**CITY OF DEXTER
PLANNING COMMISSION
REGULAR MEETING
MONDAY, APRIL 4, 2016**

RE: SLU2016-01 and CSPR 2016-02 8080 Grand Street, application received April 4, 2016; site plan dated, April 4, 2016
8080 Grand, LLC, Applicant; Don Darnell, representing

Regarding: 8080 Grand Street
Combined Site Plan Review No. 1
OHMJN: 0130-16-1031

SITE PLAN
NORTH

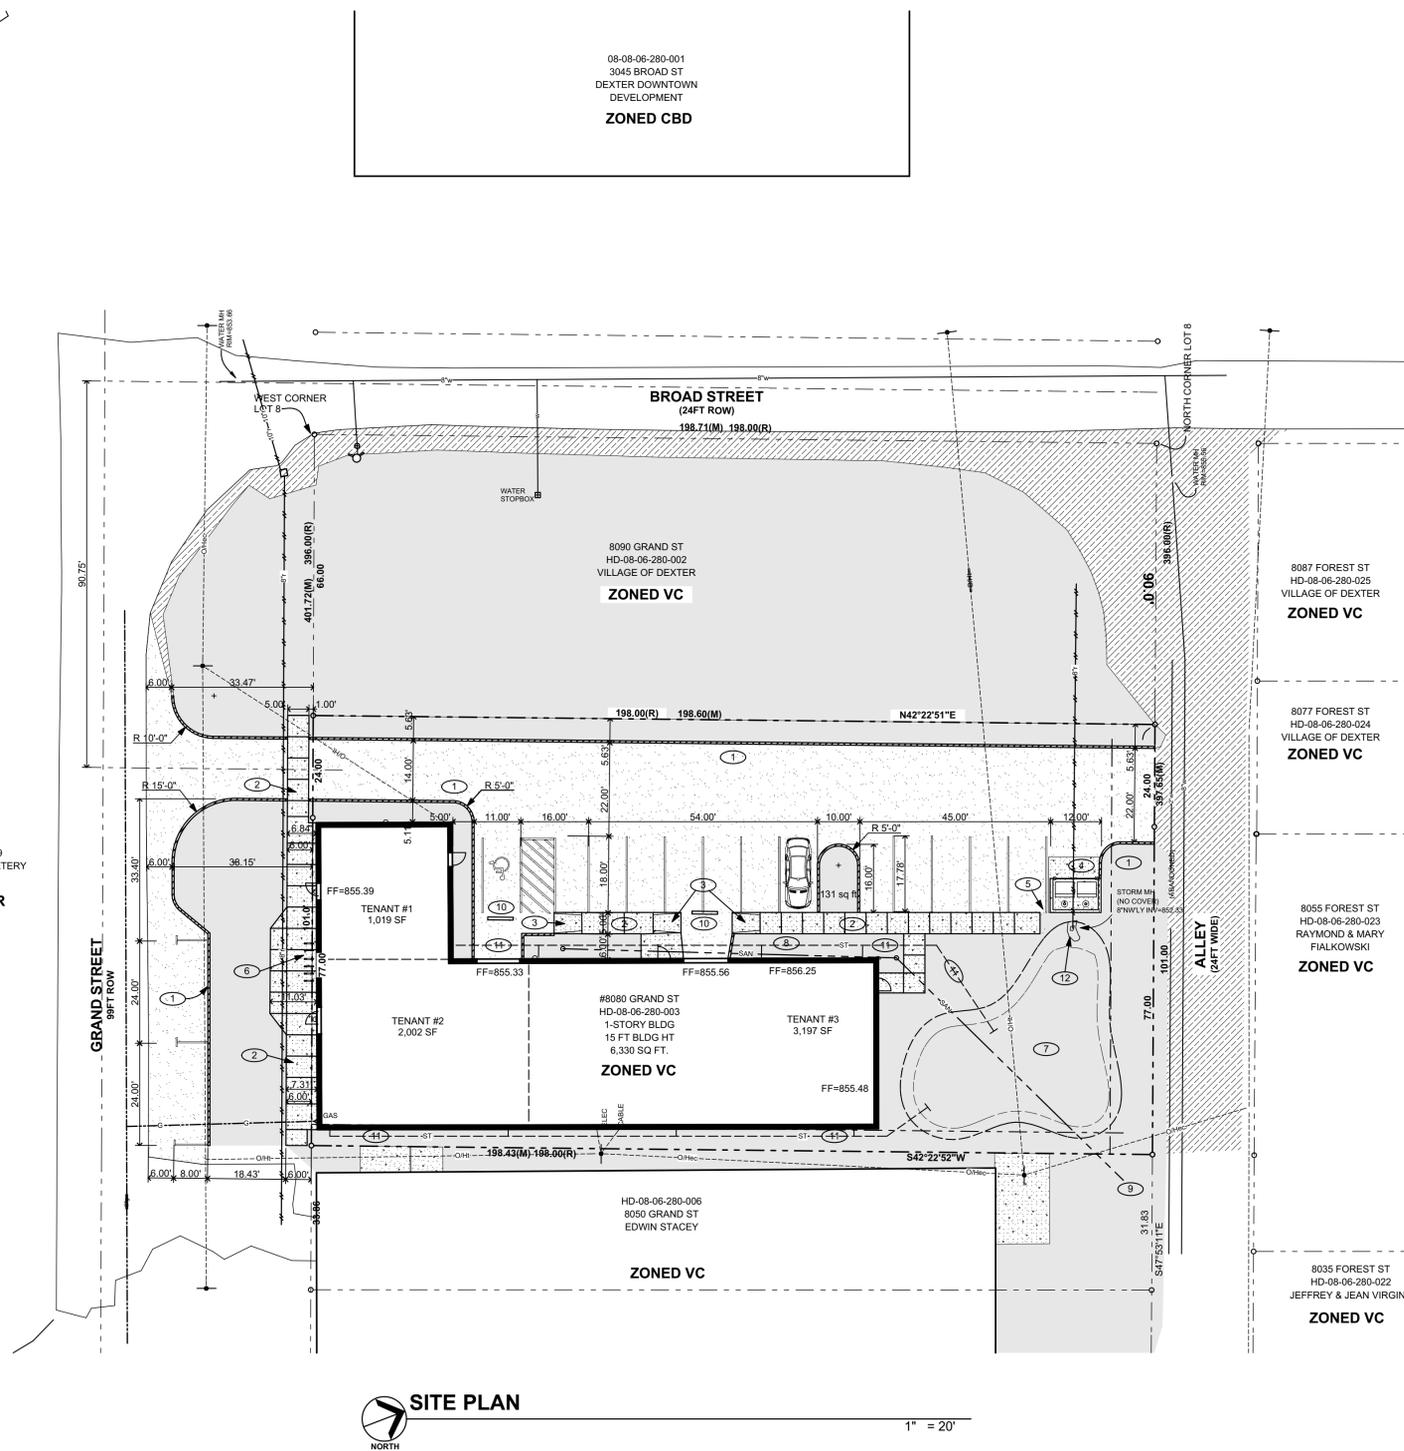
Sheet S-1 appears to propose the combination of Parcels A and B depicted on the existing conditions survey (unnumbered – Sheet 3). The legal description will need to be modified to reflect the combination of parcels. Further, we note the Sheet 3 (unnumbered) property survey has not been signed and sealed by a State of Michigan Registered Surveyor.

As presented, the applicant is not proposed any additions to the existing structure. All dimensional requirements of the VC district have been met with the exception of the existing eastern side setback non-conformity. We note the Schedule of Regulations on Sheet S-1 provides the lot width to be 77 feet, this does not account for the inclusion of Parcel A in the lot width. Further, the combined side setbacks total 28.5 feet not the 28.55 feet listed in the table.

Items to be addressed: *Correct inconsistencies in the Schedule of Regulations provided on Sheet S-1.*

The applicant has calculated the required parking on-site (Sheet S-1) to be eight (8) parking spaces. However, Section 8.02 A. 3. states, *when units of measurements determining the number of required parking or loading spaces results in a fractional space, any fraction shall be counted as one (1) additional space*. Therefore, 10 parking spaces are required. Two (2) additional on-street parallel spaces are also proposed along Grand Street (not reflected in on-site parking calculations in the above table).

No information related to how deliveries to the site will be accommodated has been provided. A note on Sheet S-1 indicates trash will be delivered to the curb for pick-up as the enclosure is not designed nor intended for truck pick-up.

LANDSCAPING PLAN

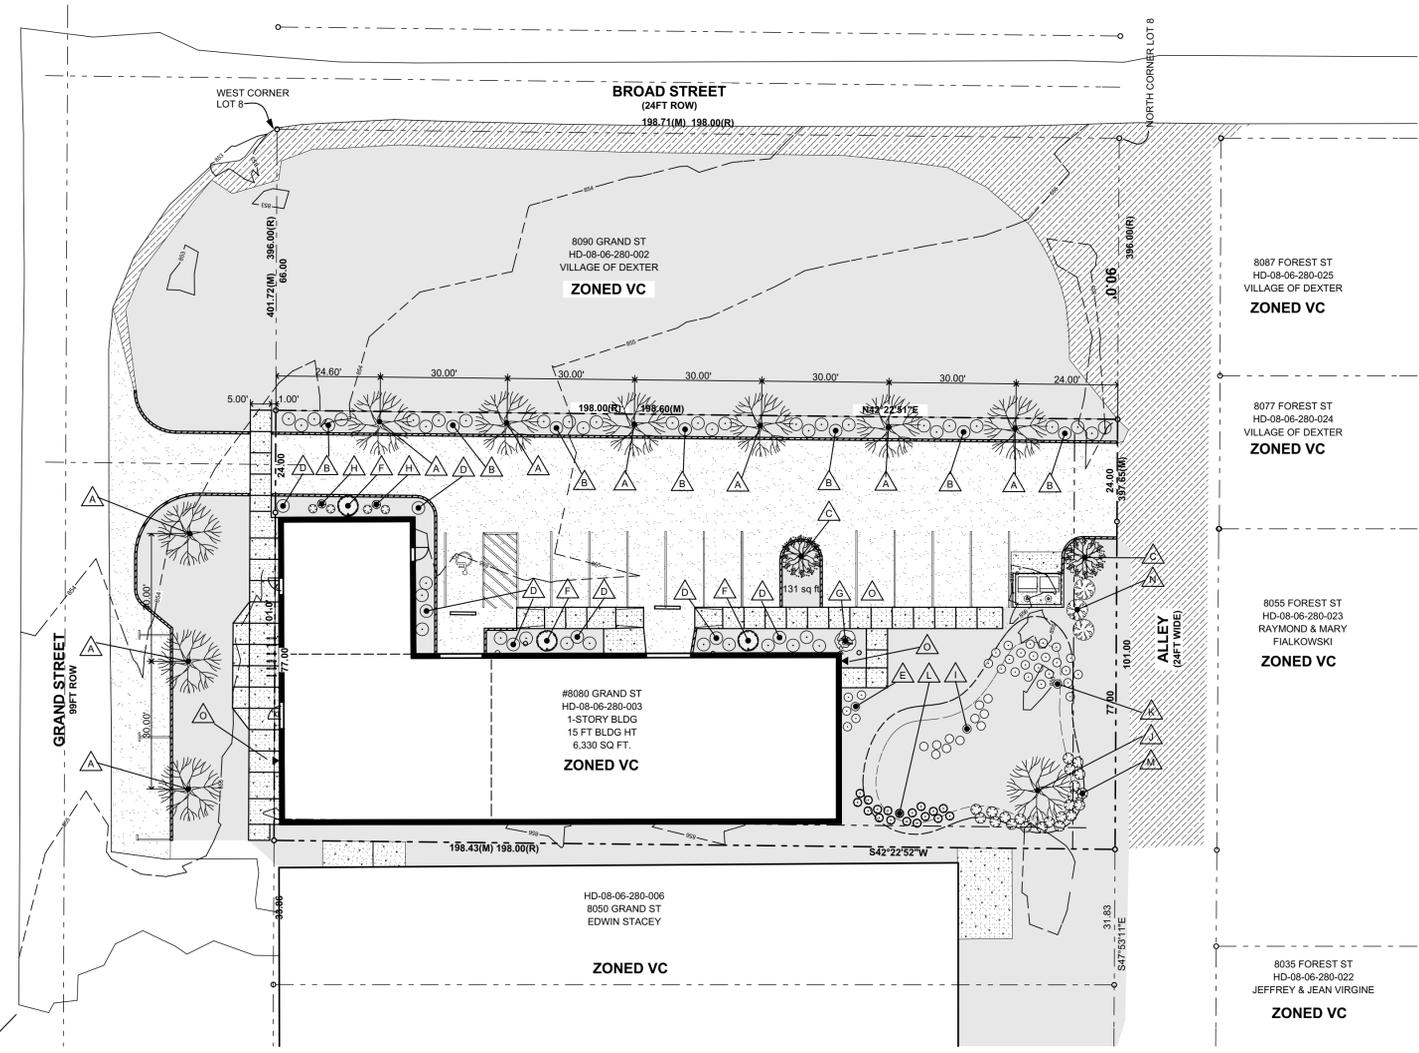
19. The rain garden plantings listed on Sheet S-5 do not appear to be in the list of the WCWRC Rules. Information on the plantings shall be provided to ensure they are able to tolerate saturated spring conditions and dry summer conditions.

Composition – Section 6.02A. notes *no more than 25% of any one genus or 10% of any one species per site plan*. As presented on the Planting Schedule (Sheet A1.01), the composition of the proposed plantings appears adequate.

SITE LIGHTING PLAN

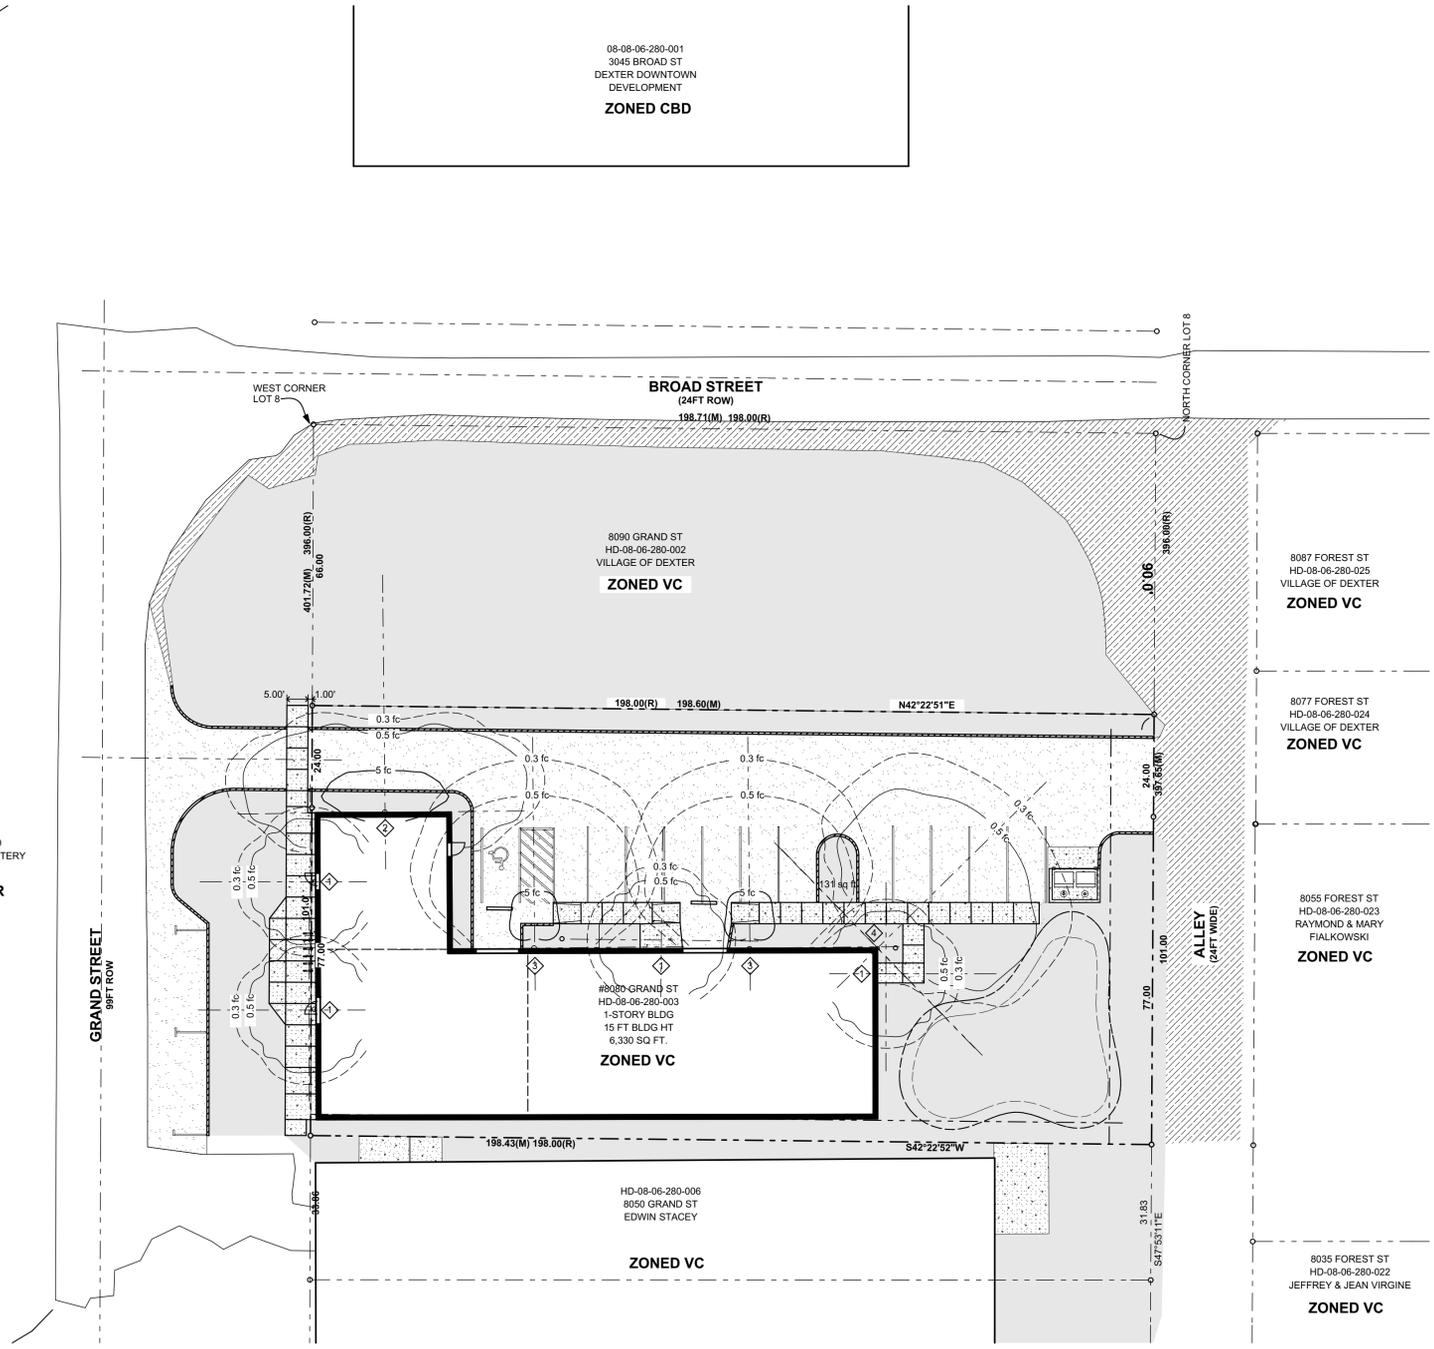
Based on the information provided, we infer seven (7) wall-mounted fixtures and one (1) 13-foot tall pole-mounted fixture are proposed. Sheet S-6 demonstrates lighting levels of 0.3 foot-candles are met along the west property line adjacent to vacant lot. A foot-candle reading of 0.5 foot-candles is demonstrated along the south property line into the right-of-way of Grand Street. Illumination levels will need to be reduced to 0.3 foot-candles in order to meet the standards of Section 3.19.

3
S7 SIDEWALK DETAIL
Scale 1" = 1' - 0"

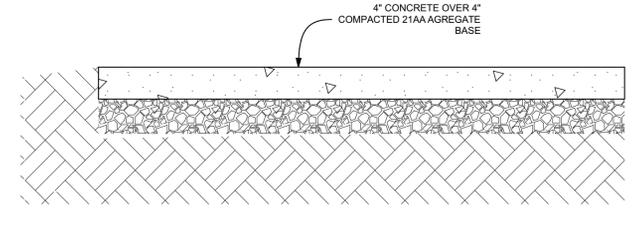
3. The sidewalk detail on Sheet S-7 shall indicate a maximum cross slope of 2.0%. Also, the sidewalk through the driveway, and an additional 5 feet adjacent to the driveway on either side, shall be 8-inch concrete with the same base thickness as other sidewalk on site.

4. The pavement cross-section detail on Sheet S-7 shows 4 inches of asphalt over a 6 inch 21AA base. The asphalt cross section shall be 5.5 inches of asphalt on 10 inches of gravel base for mixed use developments. Additionally, the HMA material of the parking lot shall be noted as 13A.

7. Curb and Gutter shall have a 4-inch 21AA aggregate base. Additionally, it shall contain 2 longitudinal rebar per MDOT standard plans.
8. A door appears to be shown on the south side of the building. The plans shall indicate the sidewalk is 5 feet wider than the door when it is open.

5
S7 DUMPSTER ENCLOSURE
Scale 1" = 1' - 0"

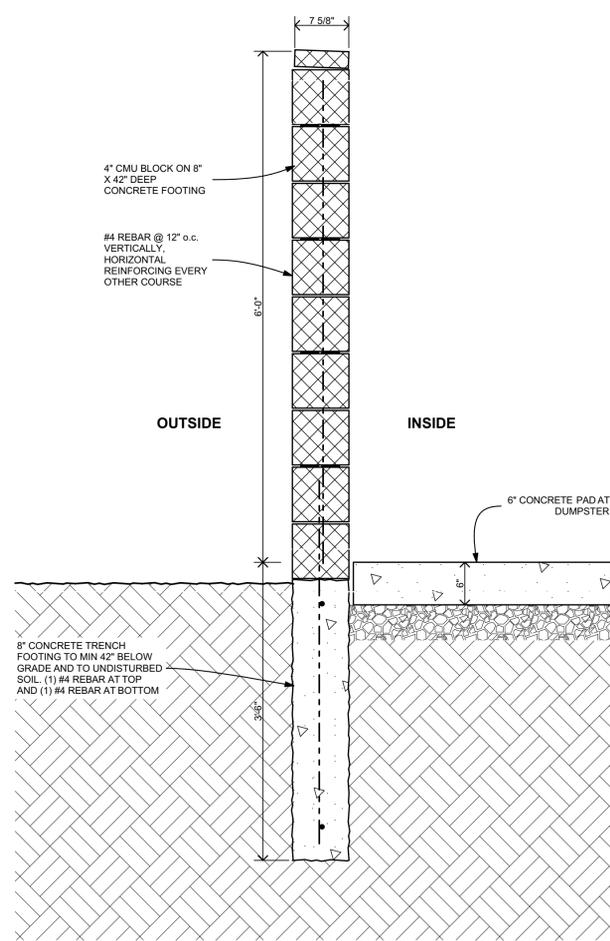
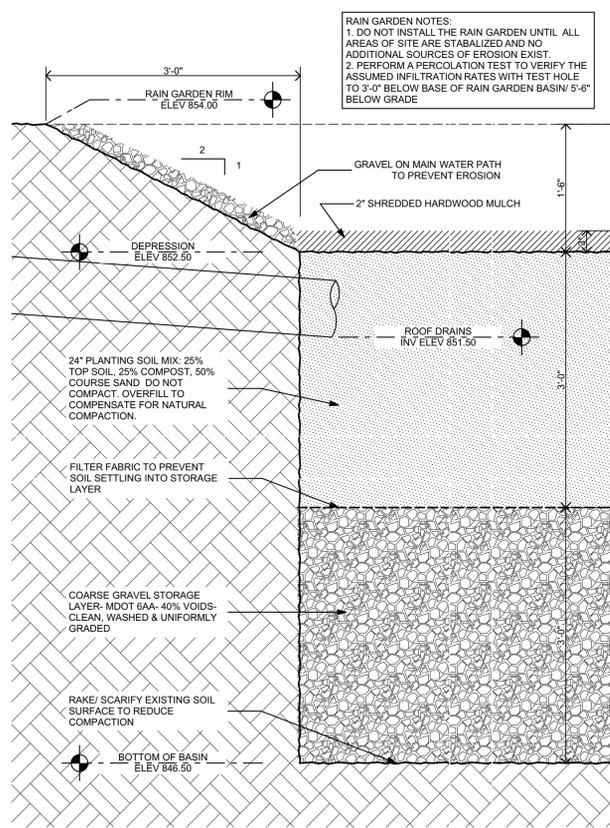
Waste Receptacle – The dumpster is located at the northeast end of the proposed parking lot. Detail of the proposed dumpster enclosure is provided on Sheet S-7. The dumpster enclosure is a masonry enclosure with wood or vinyl gate. As noted previously, trash will be moved to the curb for pick-up. We question whether the two (2) bins demonstrated on the plans will accommodate the refuse for three (3) commercial units.

2
S7 RAIN GARDEN DETAIL
Scale 1" = 1' - 0"

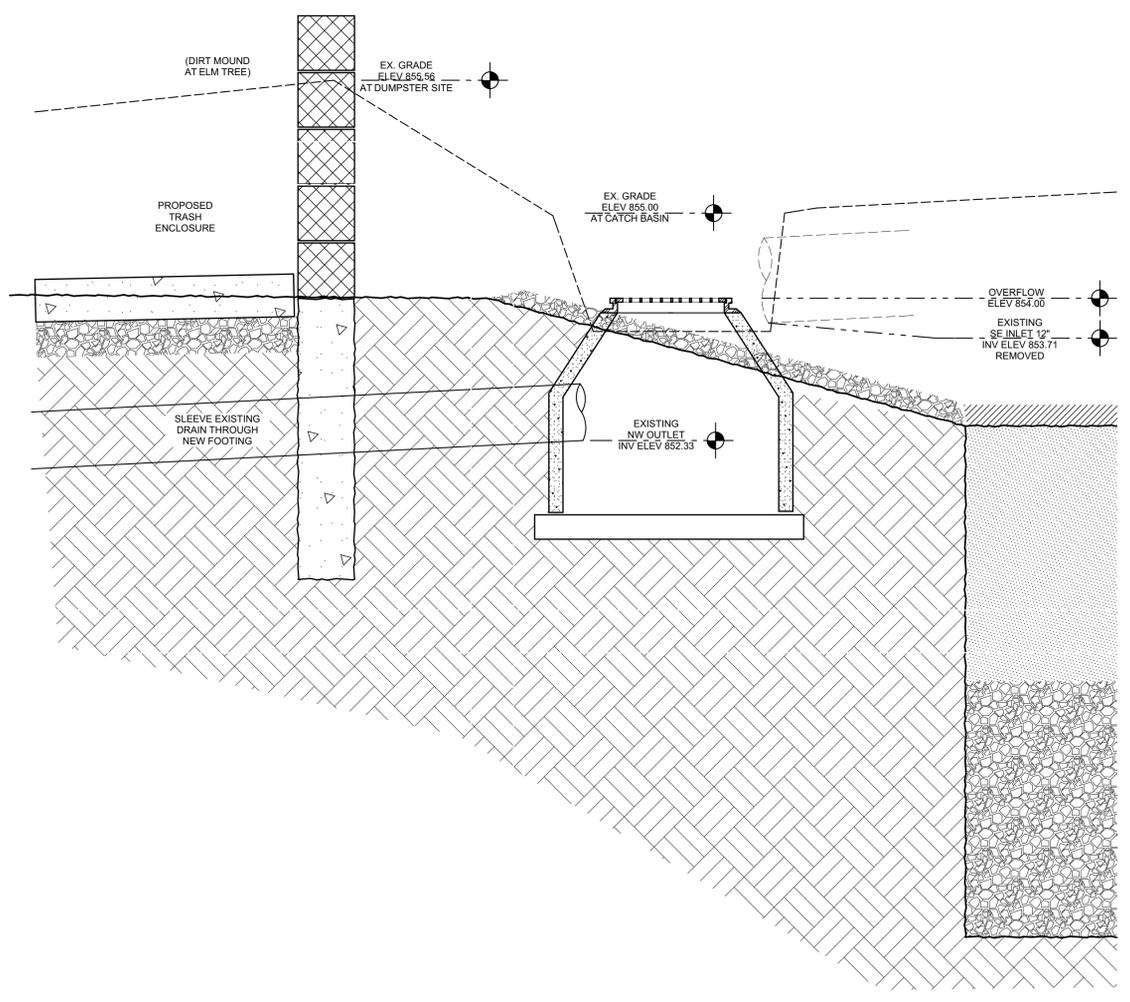
17. Per Section V of the WCWRC recommendations, the minimum setbacks for rain gardens are 10 feet from property lines and 15 feet from buildings.
18. Per Section V of the WCWRC rules, the maximum allowable slope for a rain garden is 3:1. The detail on Sheet S-7 shall be altered to reflect this requirement.

2
9 LEFT ELEVATION
3/16" = 1'-0"

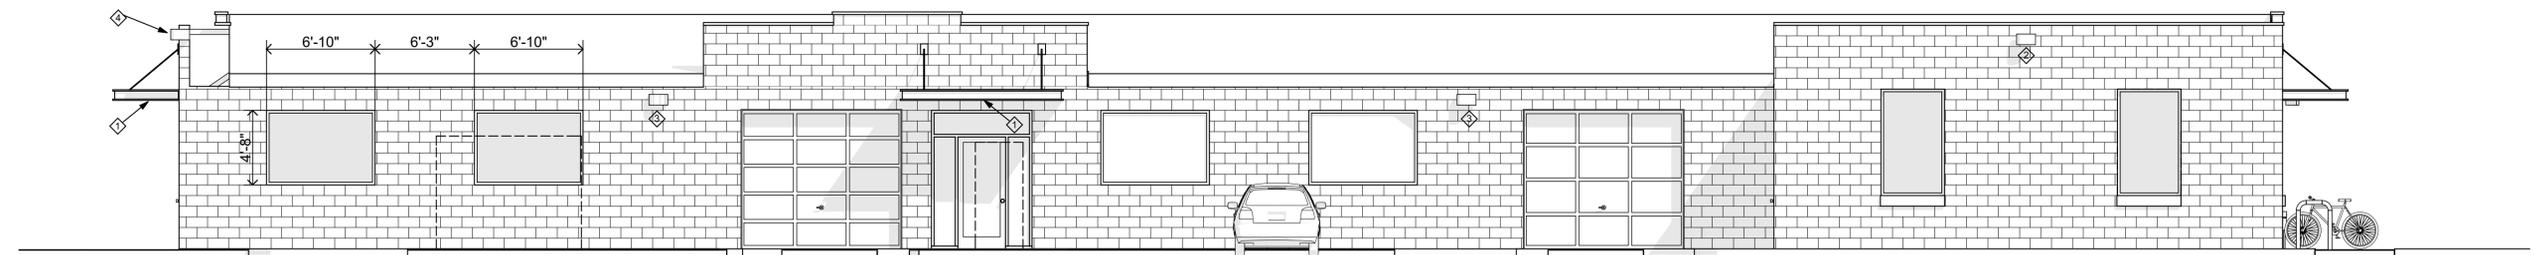
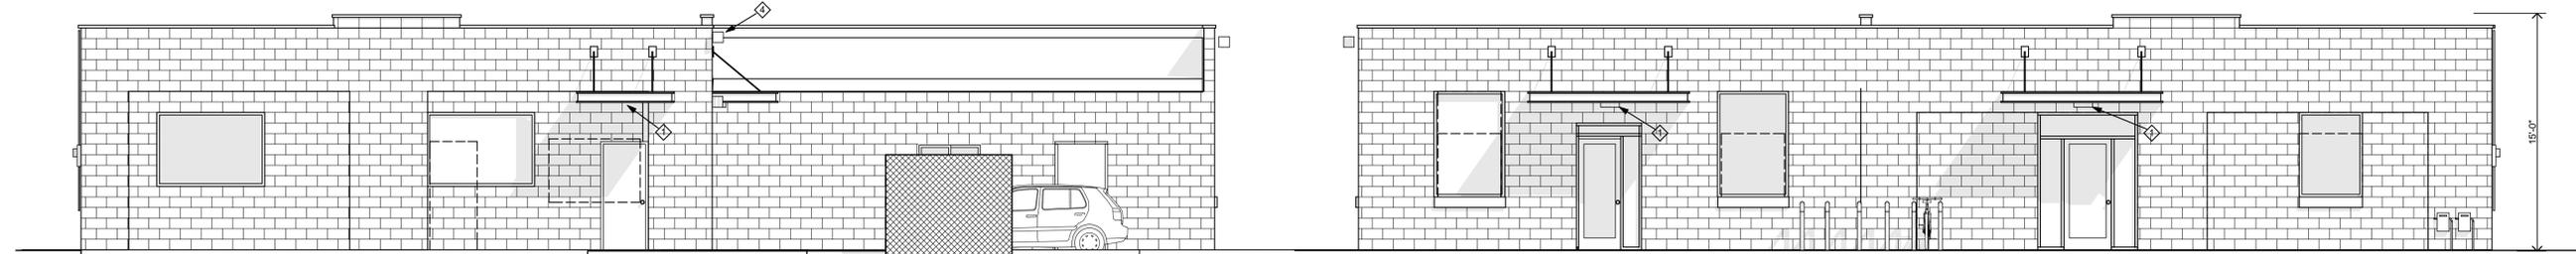
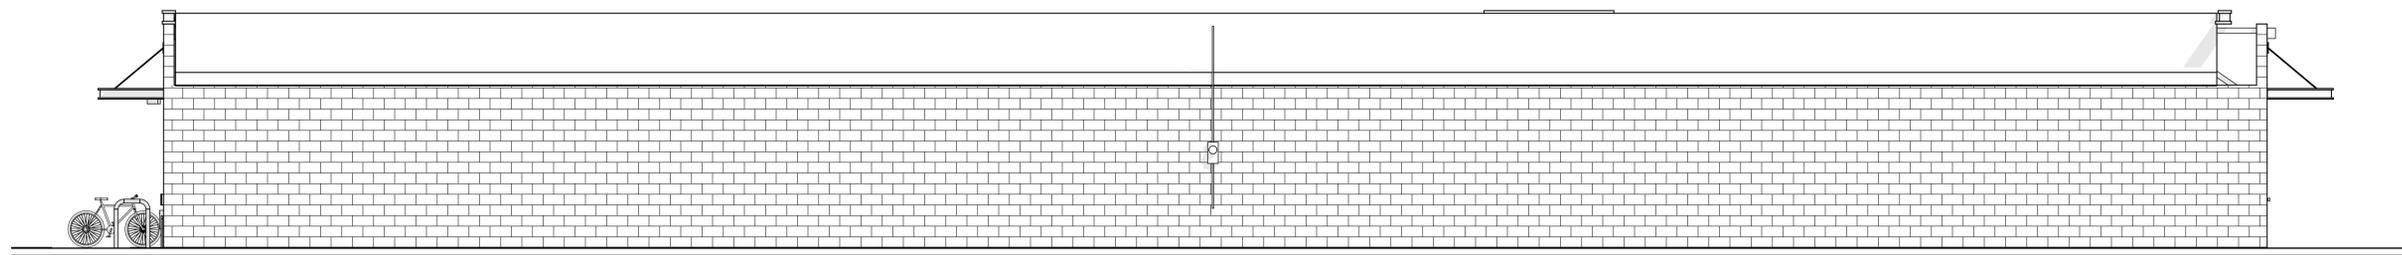
Floor plans as well as all elevations have been provided. Exterior materials will remain as currently constructed (masonry). We note the west elevation (labeled "left" on Sheet A-2) will maintain two (2) garage bays with overhead doors. As noted in the special land use review auto-service related uses are not a permitted or special land use in the VC district. The applicant should demonstrate the purpose of the remaining overhead doors/garage bays.
